"B.G.A. Technical Committee"
Technical Newsheet 3/4/77

TNS 3/4/77

1. Airworthiness Aggro. (Please add these items to the 1977 compendium of Defects and Inspections).
- 1.1. V.T.C. Open Cirrus. (Removal of VNe Restriction). The following extract of a letter from Holighaus via Southern Sailplanes dated 17/2/77 requires that we "Minimise the play of the elevator to a value of less than one millimetre, there should be no flutter possible". Compliance with this requirement will remove the B.G.A. Restriction imposed as a result of the receipt of a Yugoslavakian A.D. (Make Log Book entry of TNS 3/77 Para. 1.1.).

Rudder Cable Modifications at Rudder Pedals.

D.G. 100

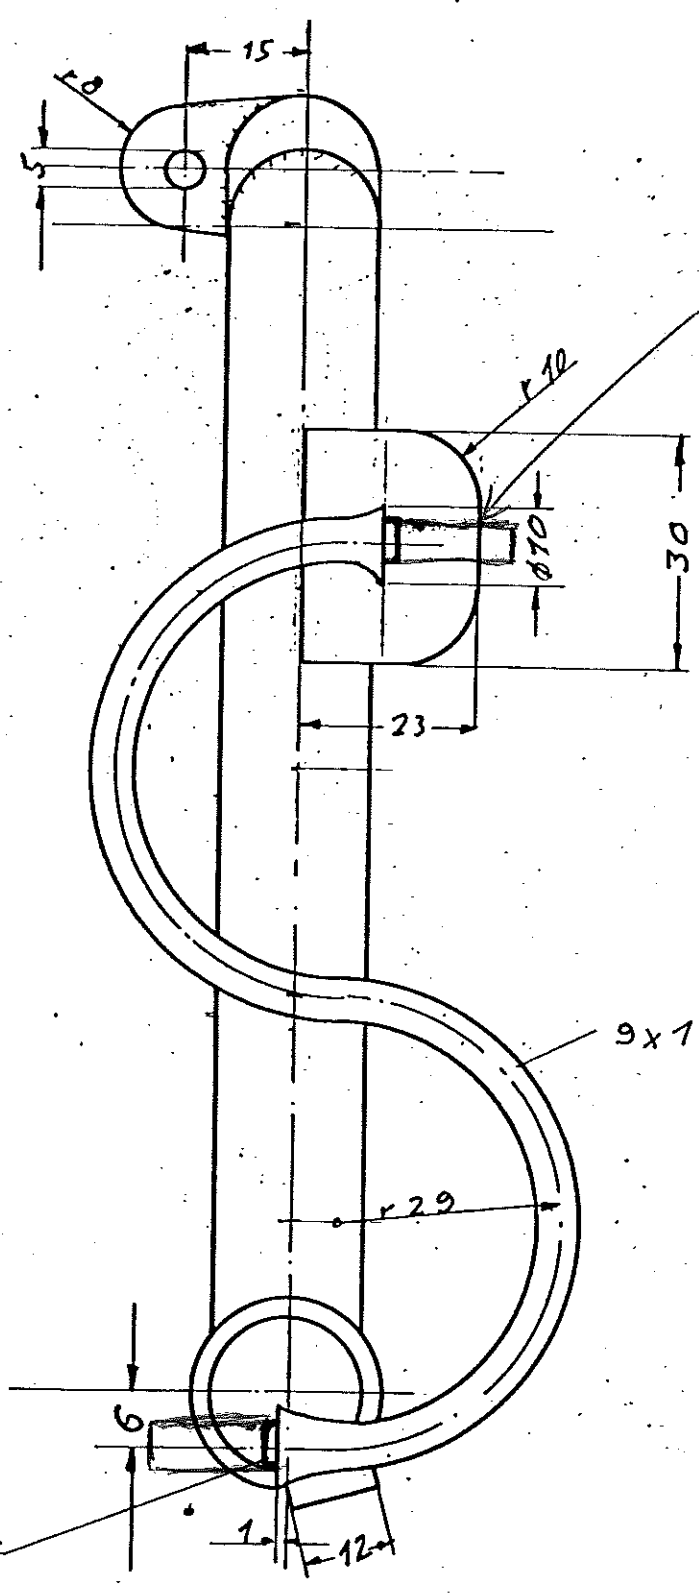
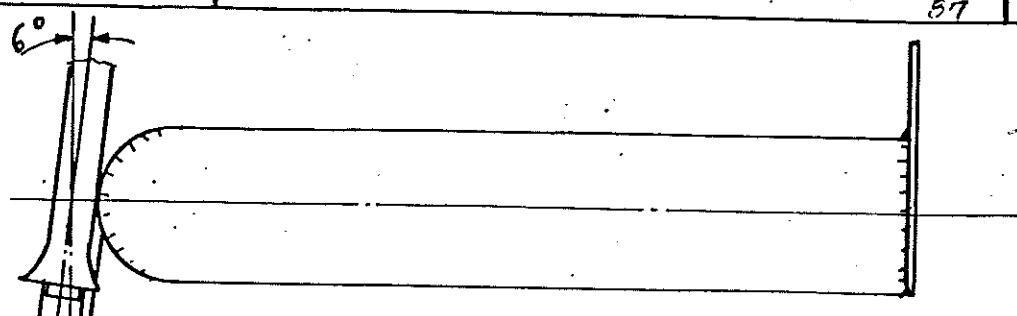
- 1.8. Chipmunk Rudder Cables. Accelerated rates of wear may be experienced at the pulleys between the two cockpits.
- 1.9. D.G. 100 Rudder Cable Modifications at rudder pedal "S" bend conduits. The attached modification has been introduced by Glaser-Dirk, and is required to be retrofitted to U.K. imports before B.G.A. Certificates of Airworthiness are issued in place of "Permits-to-Fly". (Mod Reference TNS 3/77 Para. 2.2.).

Glaser-Dirks have advised the B.G.A. in a letter dated 8/3/77, that a modification to fit nylon tubes in the "S" type conduits, has been introduced.

Before U.K. based DG100s are issued with B.G.A. Certificates of Airworthiness, the B.G.A. Technical Committee require this modification to be embodied.

Extended Nylon

Nylon Rohr
6x1
